Steven D. Capps  
Vice President  
McGuire Nuclear Station

**SUBJECT:** Duke Energy Carolinas, LLC (Duke Energy)  
McGuire Nuclear Station (MNS), Units 1 and 2  
Docket Nos. 50-369 and 50-370  
Renewed License Nos. NPF-9 and NPF-17  
Response to Request for Additional Information Regarding Overall Integrated  
Plan in Response to Order EA-12-051, "Reliable Spent Fuel Pool Instrumentation"  
(TAC Nos. MF 1062 and MF 1063)

REQUEST FOR ADDITIONAL INFORMATIONOVERALL INTEGRATED PLAN IN RESPONSE TOORDER EA-12-051, "RELIABLE SPENT FUEL POOL INSTRUMENTATION"DUKE ENERGYMCGUIRE NUCLEAR STATION, UNITS 1 AND 2DOCKET NOS. 50-369 AND 50-370**1.0 Introduction**

FIGURE 1  
PRIMARY CHANNEL  
 (LEVEL RANGE MINIMUM EL. 746' TO APPROX. EL. 775')

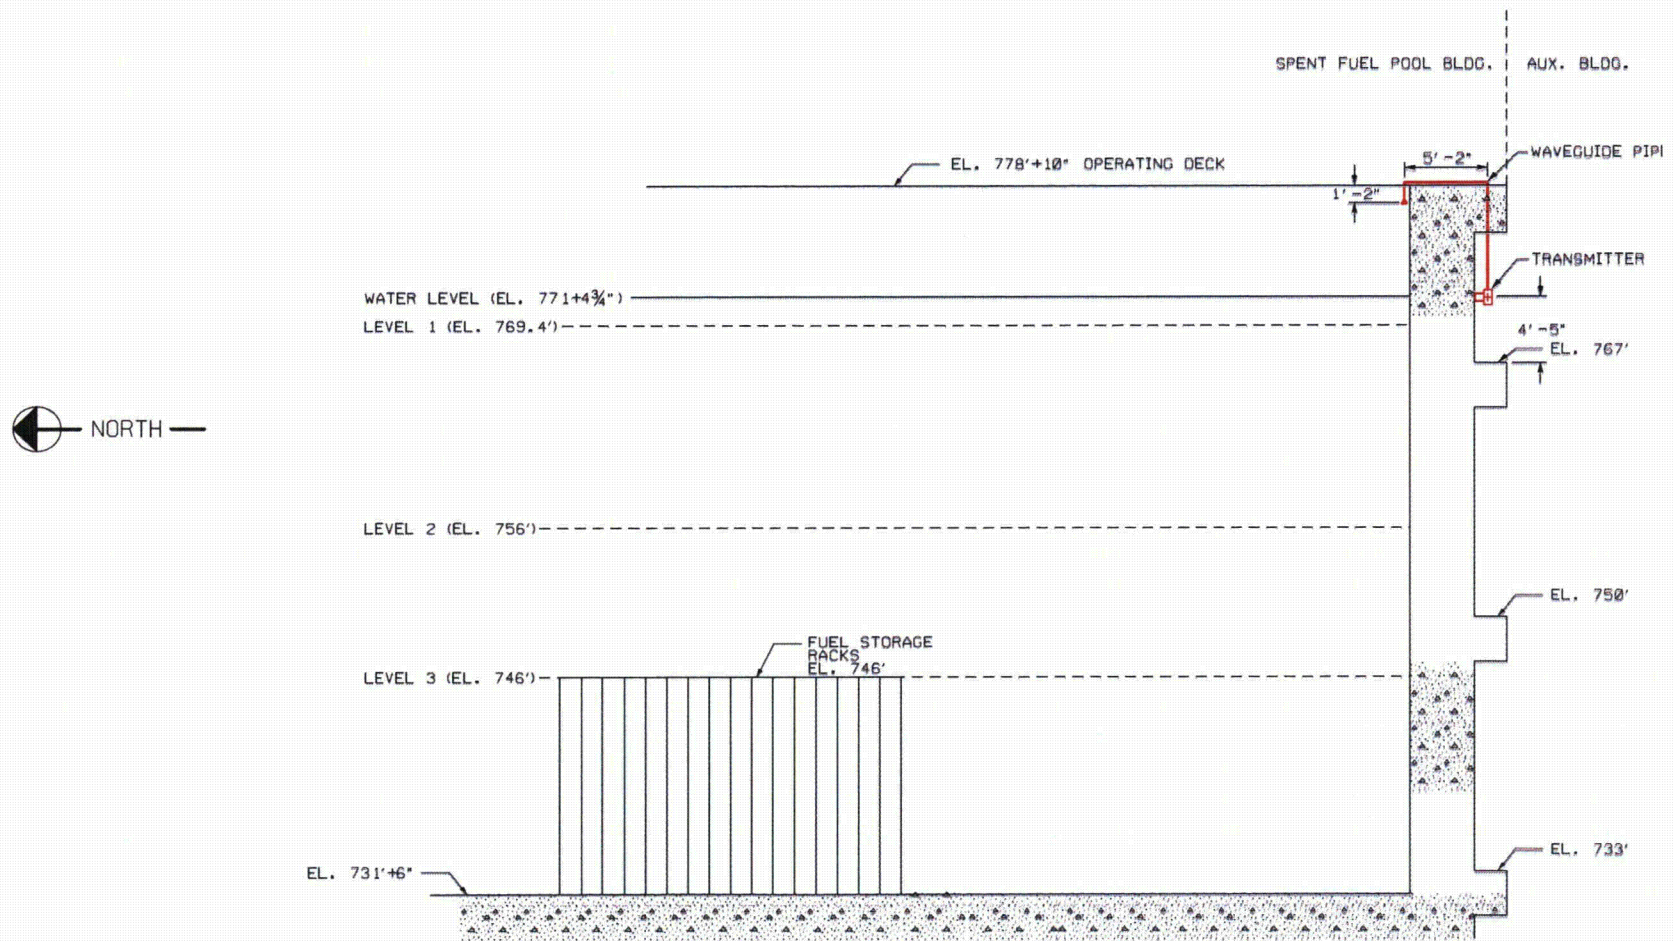
- c) A clearly labeled sketch depicting the elevation view of the proposed typical mounting arrangement for the portions of instrument channel consisting of permanent measurement channel equipment (e.g., fixed level sensors *and/or* stilling wells, and mounting brackets). Indicate on this sketch the datum values representing Level 1, Level 2, and Level 3 as well as the top of the fuel. Indicate on this sketch the portion of the level sensor measurement range that is sensitive to measurement of the fuel pool level, with respect to the Level 1, Level 2, and Level 3 datum points.

- a) The normal SFP water level is 771.4' Elevation. The SFP cooling pump suction piping submergence is lost when water level decreases below 767.8' Elev. Abnormal procedures secure the SFP cooling pump when water level decreases to 2' below normal. Thus, the NEI 12-02 "Level 1" datum is considered to be 769.4' Elevation.
- b) Adjacent SFP hardware stored in the vicinity of the primary SFP level instrumentation will be evaluated with-respect to potential physical seismic interaction and interference with proper operation of the primary level instrumentation. The primary SFP level instrumentation located in the SFP area contains no organic materials which are susceptible to degradation due to exposure to radiation, heat, or steam.

- c) Elevation views depicting the primary and back-up SFP level channel lay-outs, monitoring ranges, and required NEI monitoring levels are provided in FIGURES 1 and 2. The figures depict Unit 1, and are typical for Unit 2.

FIGURE 3 – Primary Level Channel Plan View

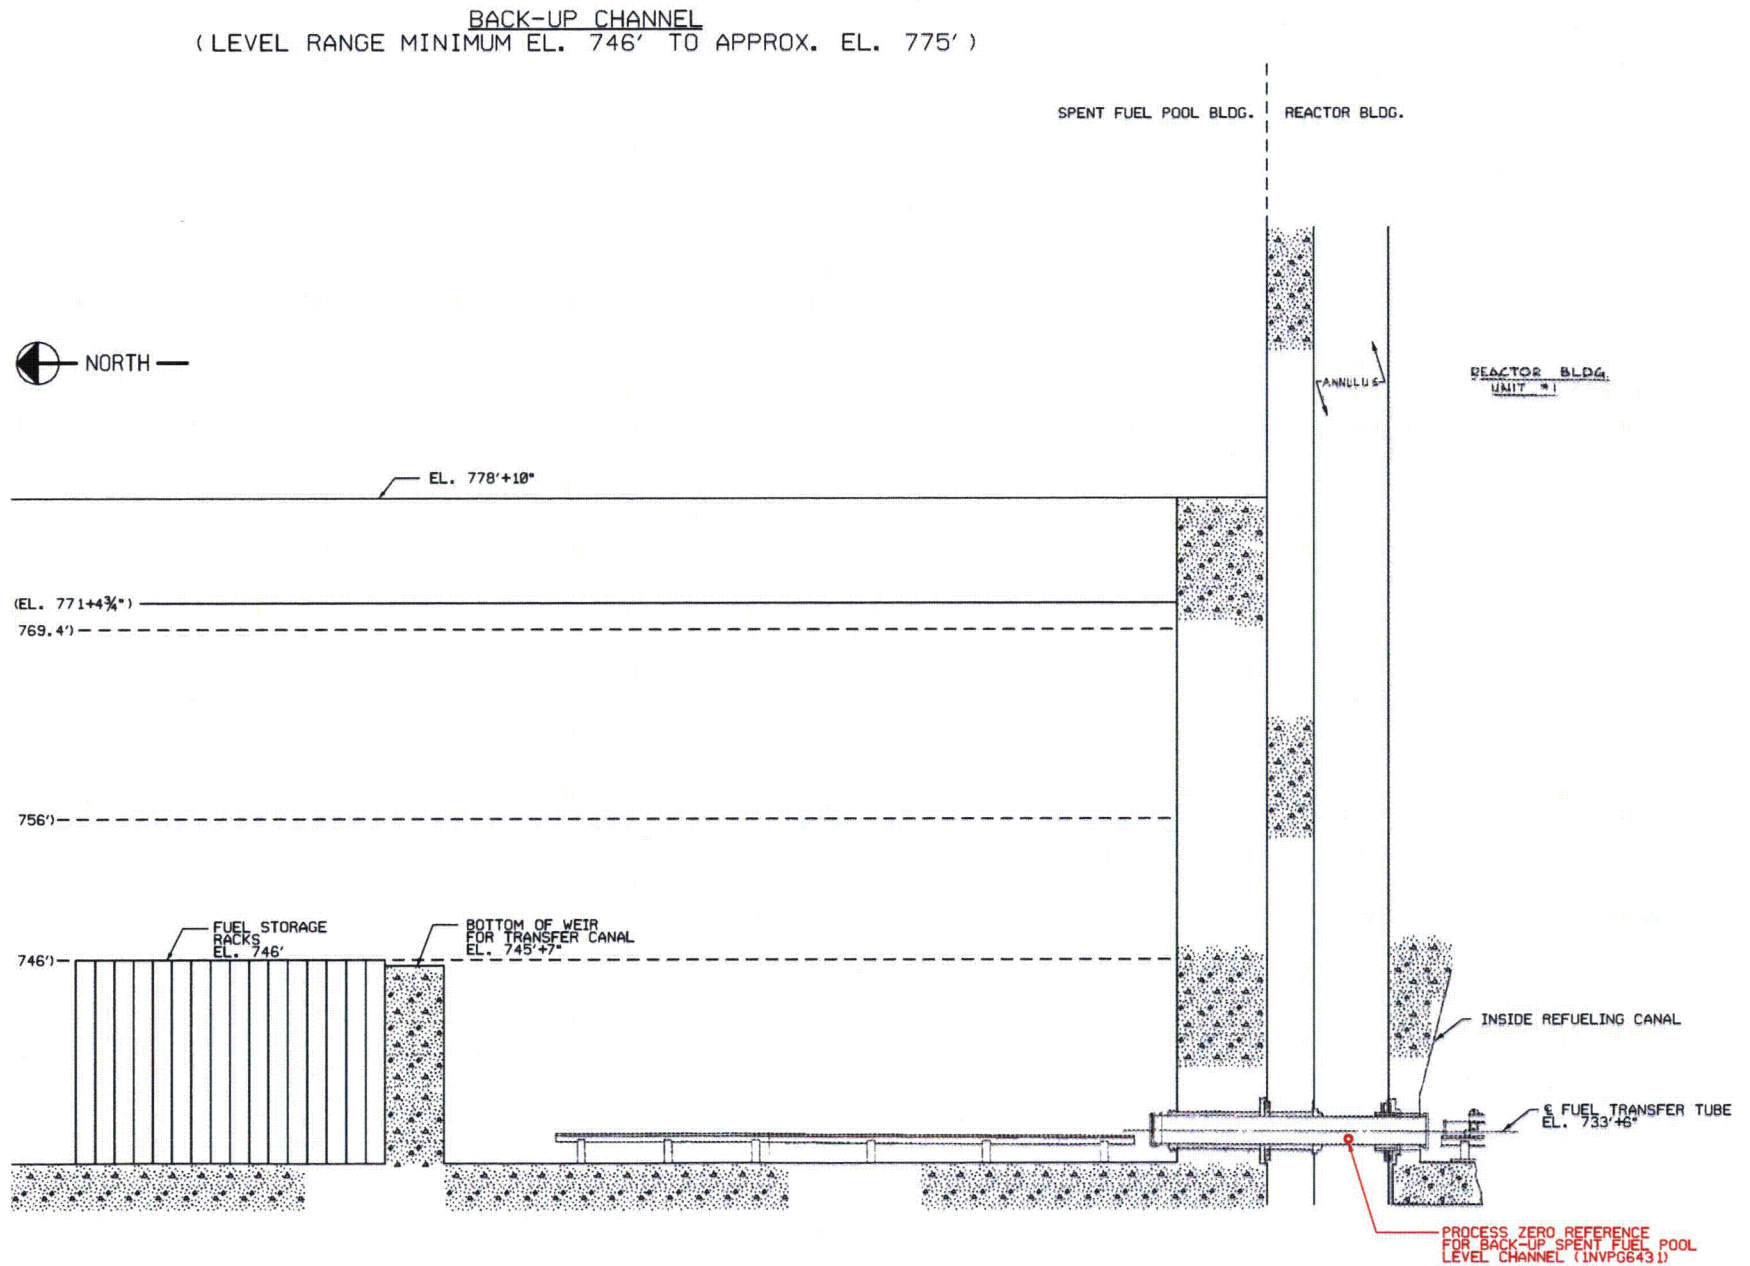
Please provide a clearly labeled sketch or marked-up plant drawing of the plan view of the SFP area, depicting the SFP inside dimensions, the planned locations/placement of the primary and back-up SFP level sensor, and the proposed routing of the cables that will extend from the sensors toward the location of the read-out/display device.

- a) A clearly labeled sketch or marked-up plant drawing of the plan view of the SFP area, depicting the SFP inside dimensions, the planned locations/ placement of the primary and back-up SFP level sensor, and the proposed routing of the cables that will extend from the sensors toward the location of the read-out/display device.
- b) Address how adjacent hardware stored in the SFP will not create adverse interaction with the fixed instrument location(s).

A Unit 1 plan view (typical for Unit 2) of the SFP area and primary SFP level channel location is provided in FIGURES 1 and 3. The wave guided radar pipe is routed slightly above the SFP operating deck, and through a floor core bore penetration down to the sensor electronics located on the 767' Elevation of the Auxiliary Building, and indication/display is provided in the main control room.

Physical layout drawings for cable routing were not readily available, as they are normally identified on cable routing cards. Alternatively, a verbal description of the general cable routing is provided. The primary SFP level channel is provided non-essential AC power from a local area termination cabinet on 767' Elevation of the Auxiliary Building. A local control panel is located adjacent to the sensor electronics located on the 767' Elevation of the Auxiliary building. The local control panel houses a field level indication/display and the battery back-up power supply. A field routed cable connects the control panel to the adjacent sensor electronics. The signal cable is routed from the sensor electronics to the cable spread room and to the indication on the main control board 1/2MC9. All associated channel electronics, and power/signal cabling are located in the Seismic Category I Auxiliary Building, and/or Control Room.

- a) Refer to FIGURES 3 and 4 provided in response to RAI #2, and the response to RAI #2.
- b) Potential physical interaction effects of SFP hardware/tools in the vicinity of the primary SFP level sensor will be evaluated as described in response to RAI #1 b), and are not applicable to the remotely located SFP back-up level channel. As part of the engineering change process, procedural controls are planned to govern storage of SFP equipment and to avoid the potential for adverse interaction with the primary SFP level channel.
